MAC-ENC-MTP-047

REHABILITATION STRATEGY

The Rehabilitation Strategy (the Strategy) is the standard for rehabilitation at Hunter Valley Energy Coal Pty Ltd (HVEC). The Strategy provides a framework for landform design and revegetation aligned with Regulator and community expectations.

Figure 9: Predicted view of landform from Yammanie Road Muswellbrook: A –landform at 2016, B – landform 5 years after completion, C - 10 to 15 years after completion, covered predominately with box woodland.

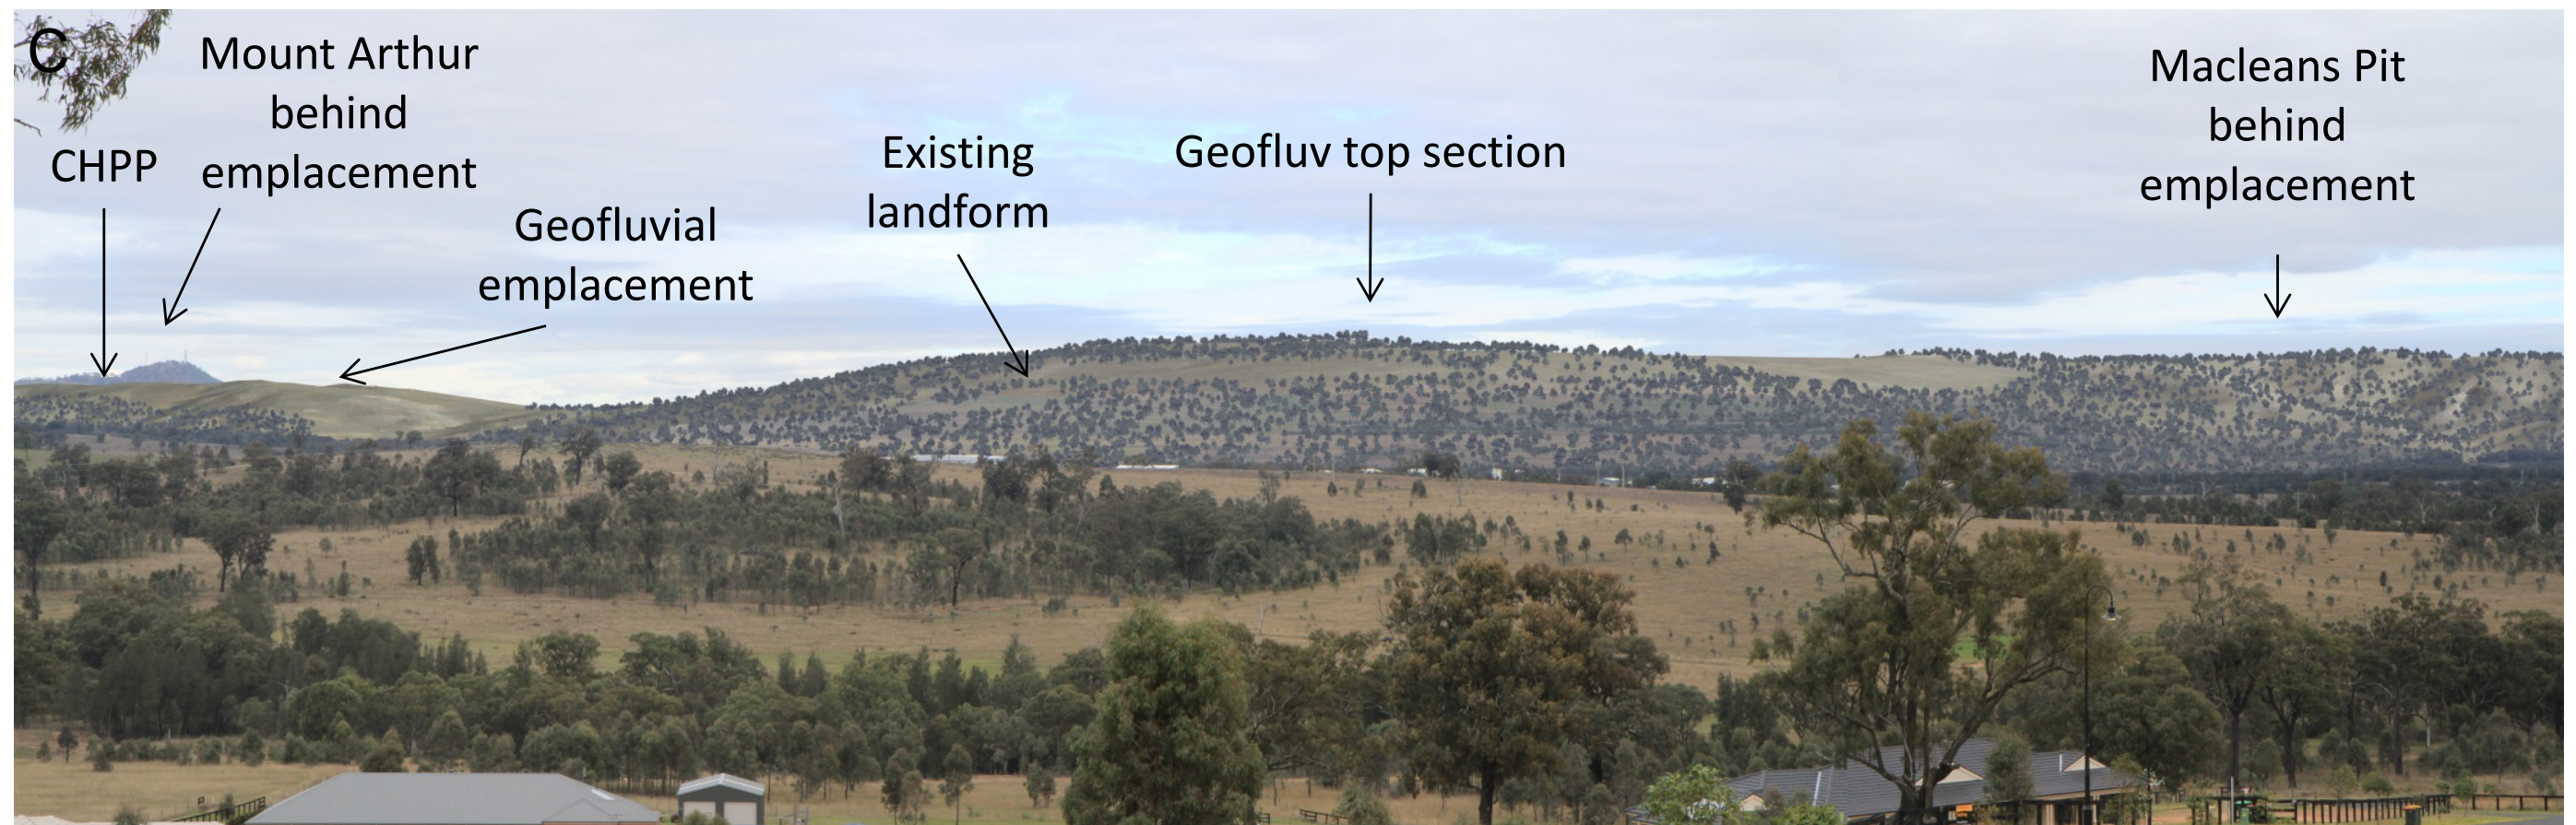
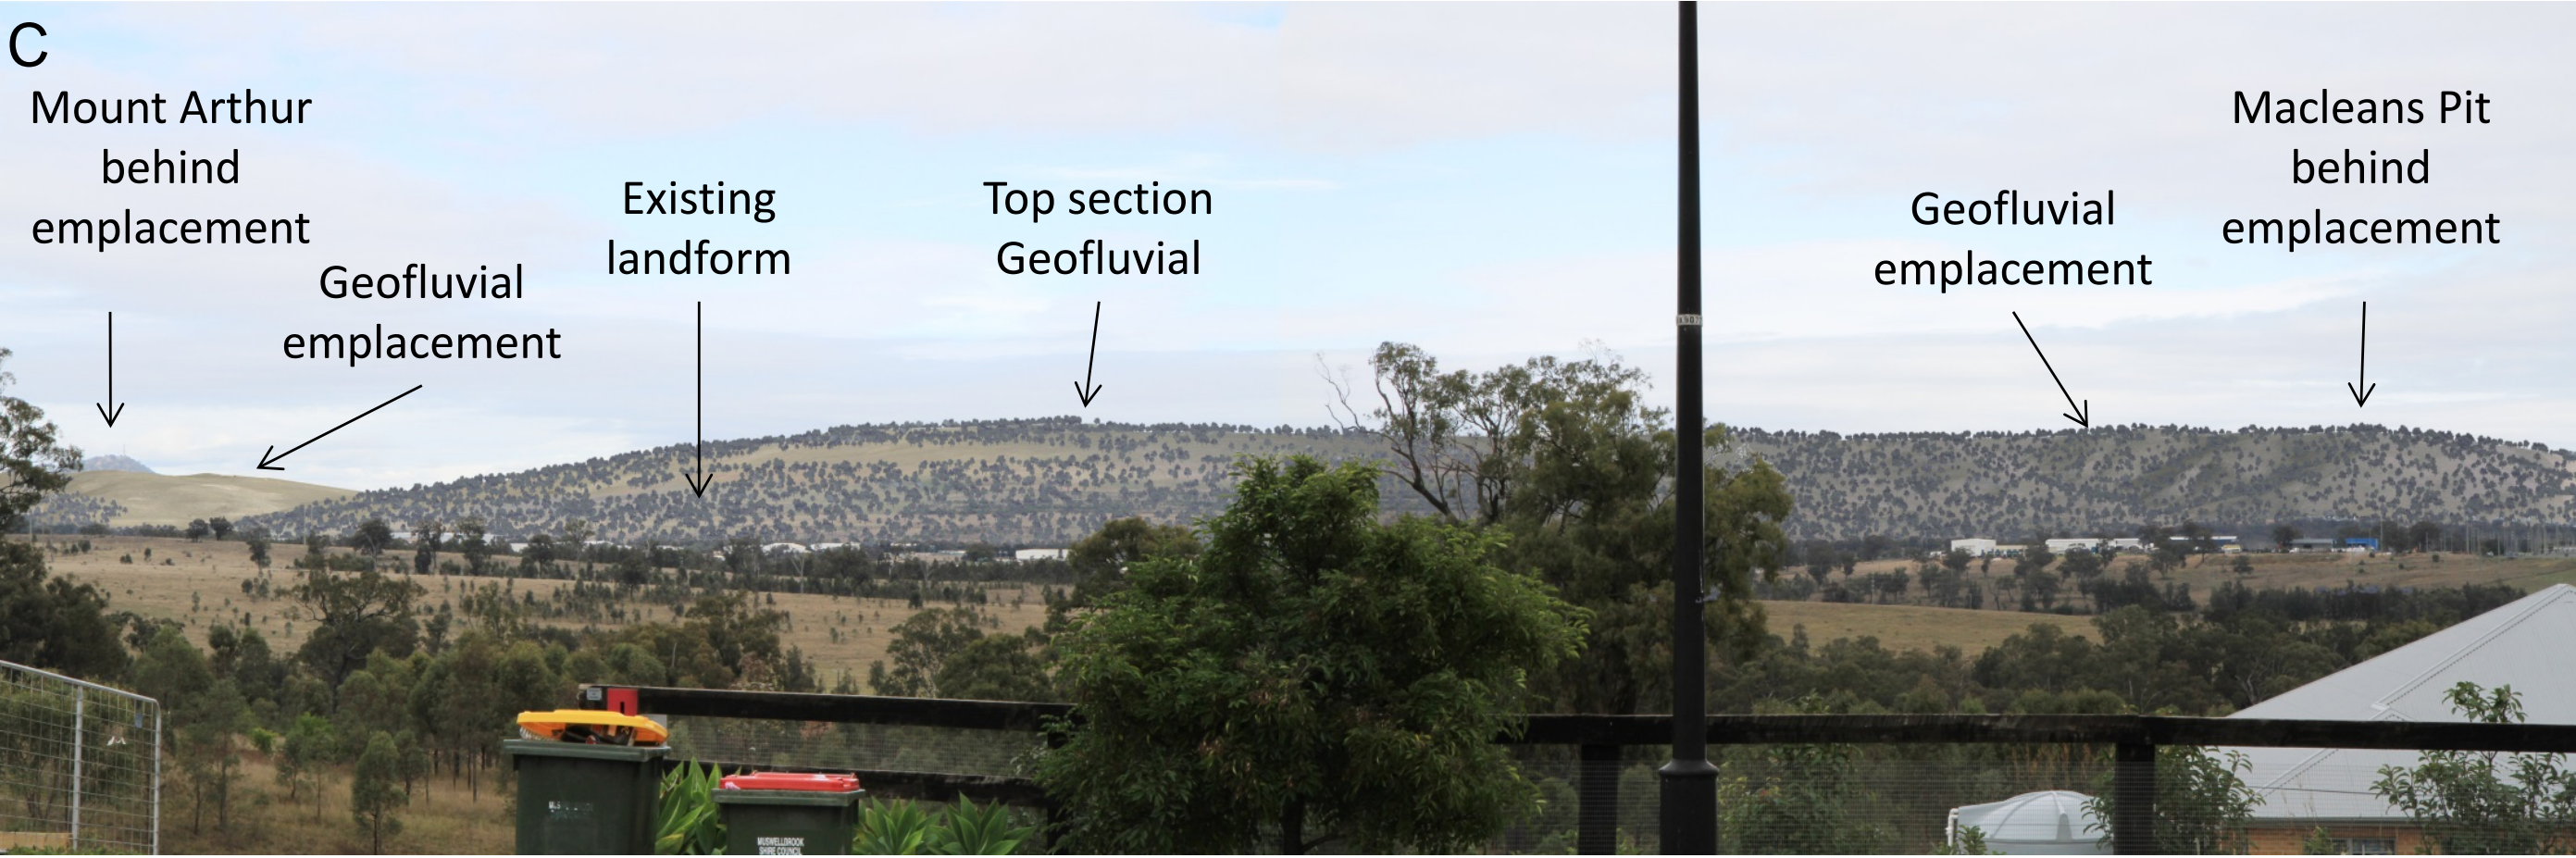
- *Table 14 in the development consent requires Mt Arthur Coal to integrate micro relief into the final landform design. Whilst the Strategy shows visual montages of how this may look at the completion of mining, further detail is required in relation to the following:*
 - *A polygon to show where these natural landform design principles will be implemented – further landform design details can be provided in the MOP*
 - *Justification for where these principles will not be adopted on site (e.g. existing*

- *Include visual montages that show key interim stages (eg. Upon landform completion, 5 years after completion, 10 -15 years after completion)*
- *Enhance visual montages by including labelling to highlight the natural landscape features integrated into the final landform.*
- *It is the expectation that detailed landform design will be presented in the MOP for submission to DRE. As discussed at the DRE / BHP Billiton meeting on 23 August 2016, MOP Plans should be developed separately for the different zones on site in order to provide better granularity in landform design.*

- Vegetation types, and pasture locations are shown in Figure 3b of the MOP and figure 3 of the new rehabilitation strategy.
 - Further staged montages will be included in the Strategy for MacLeans area. Labels on the montage will be improved for explanation

FIGURE 11. Proposed final landform drainage plan

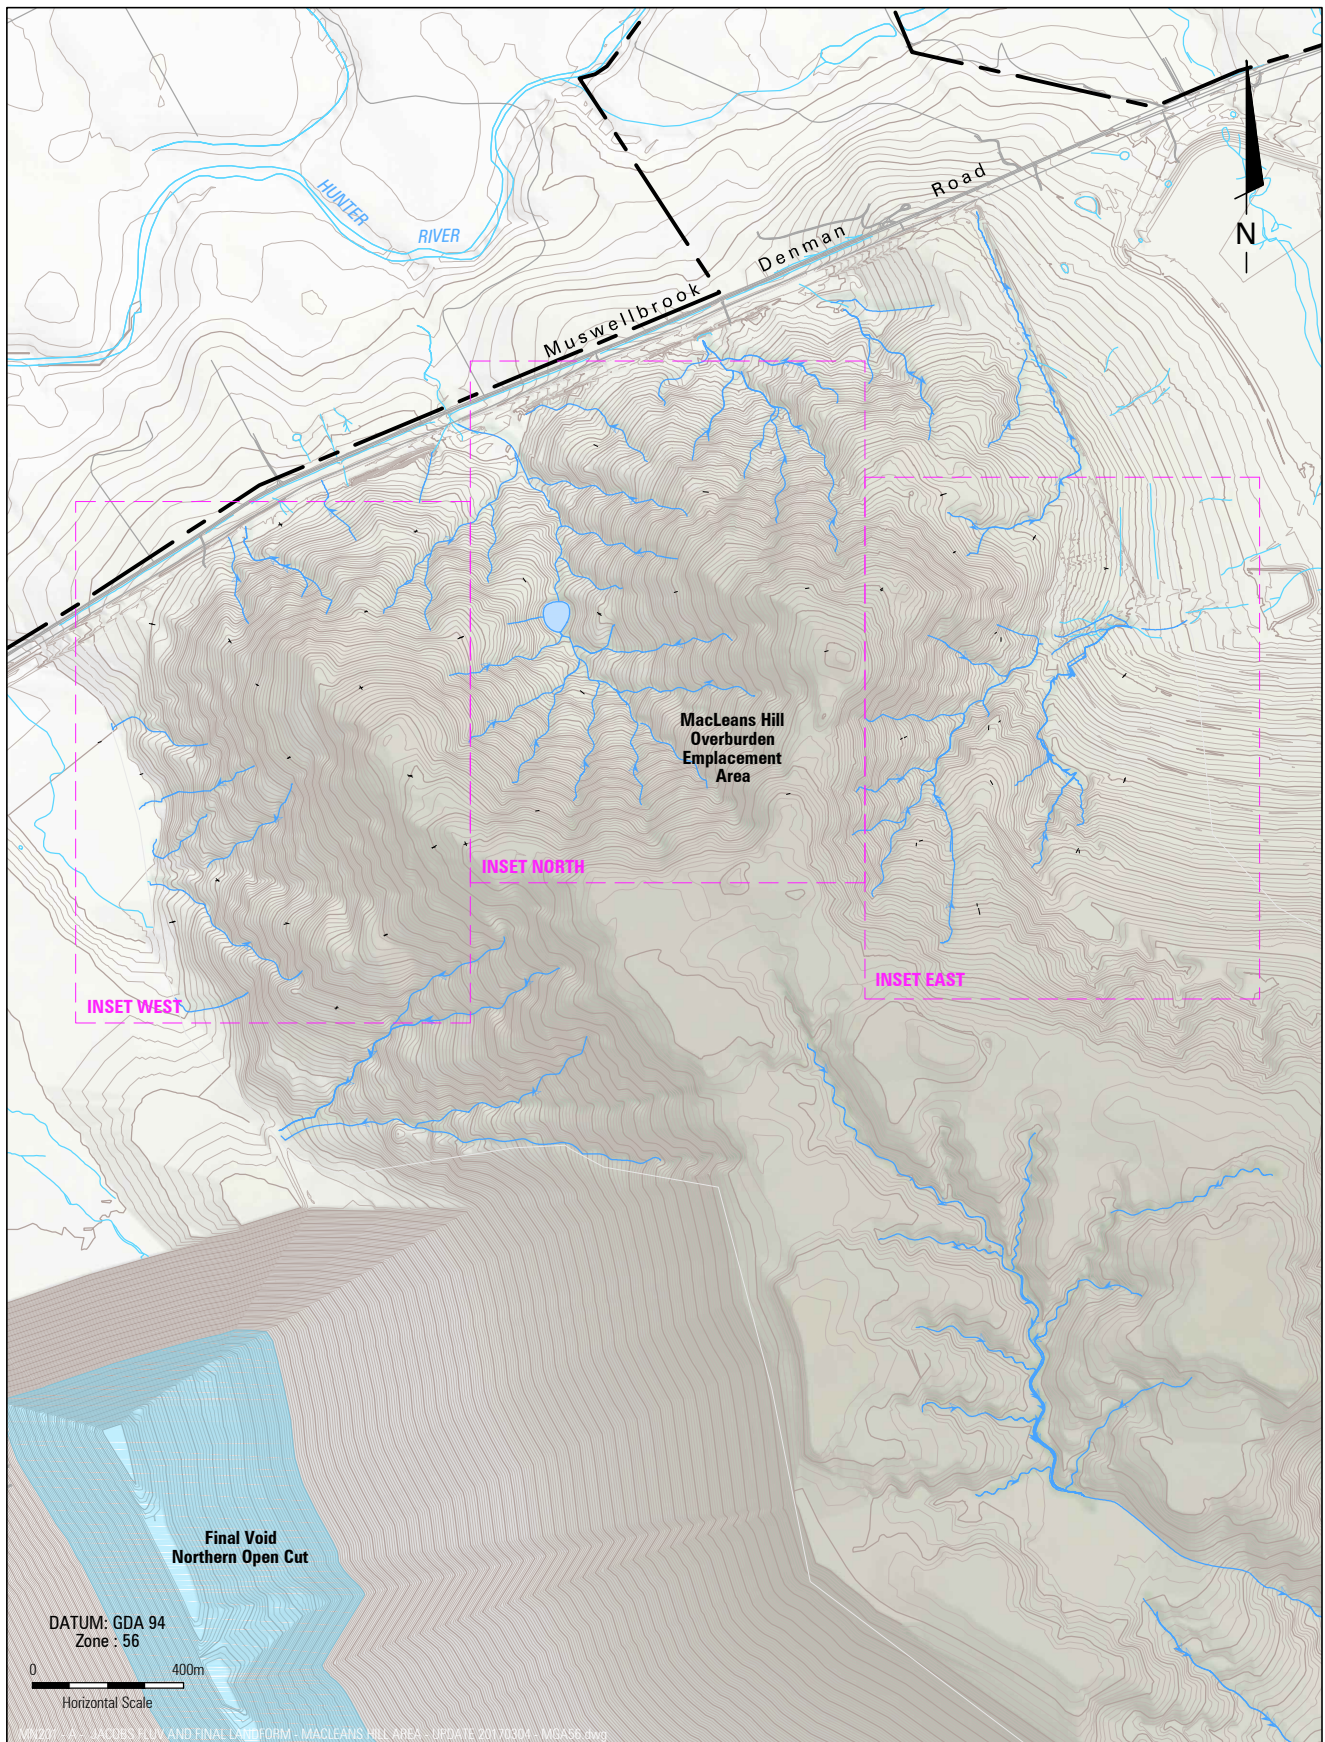
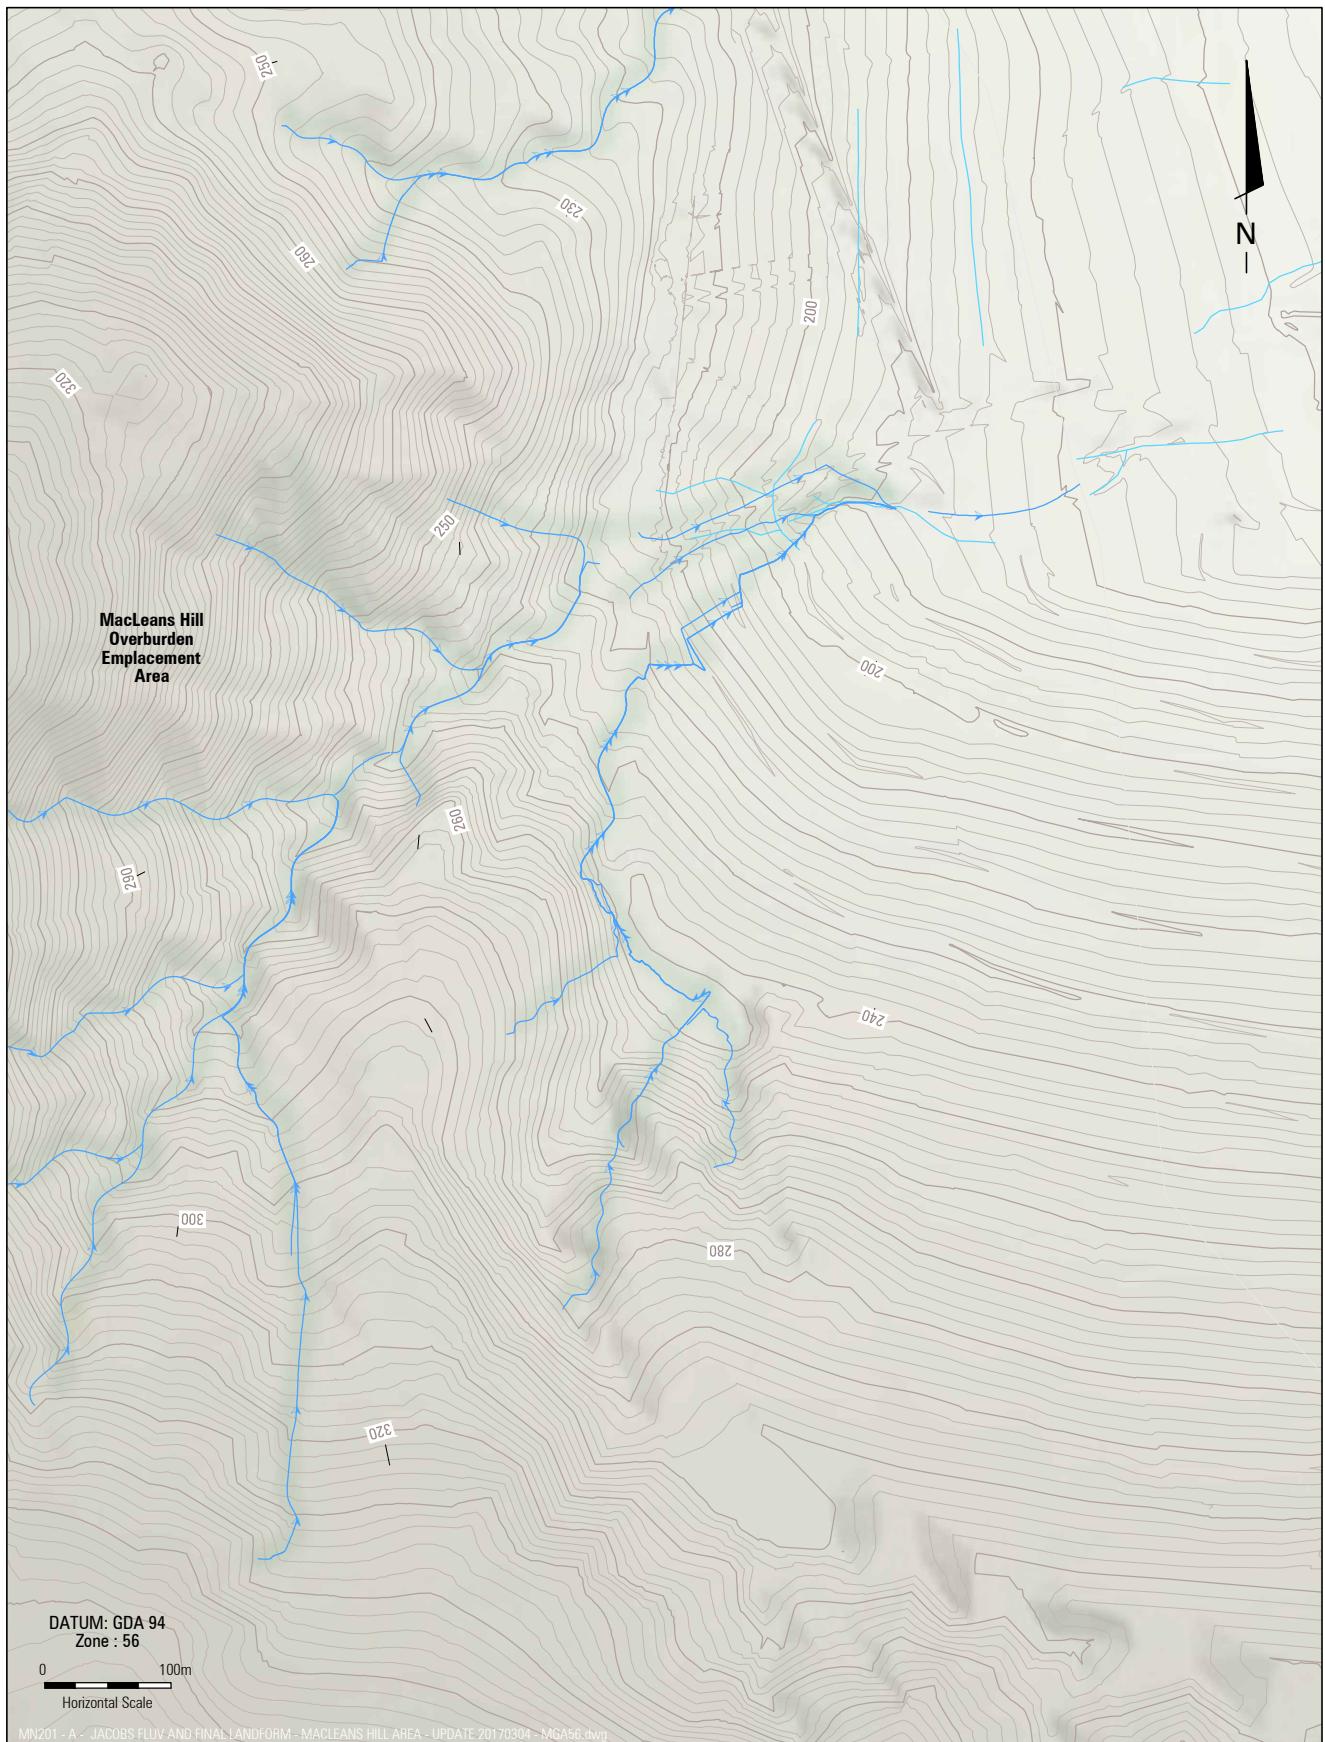
- MSC discussed the new contour figures (11 and 12) in the rehabilitation strategy and stated that it would be good to see where the pasture and vegetation areas will be for the final landforms. MAC pointed out that the domains and post mined pasture and woodland areas are presented on Figure 3 in the strategy and figure 3b in the MOP in more detail. These figures also include new contouring for MacLeans and the VD emplacement areas.
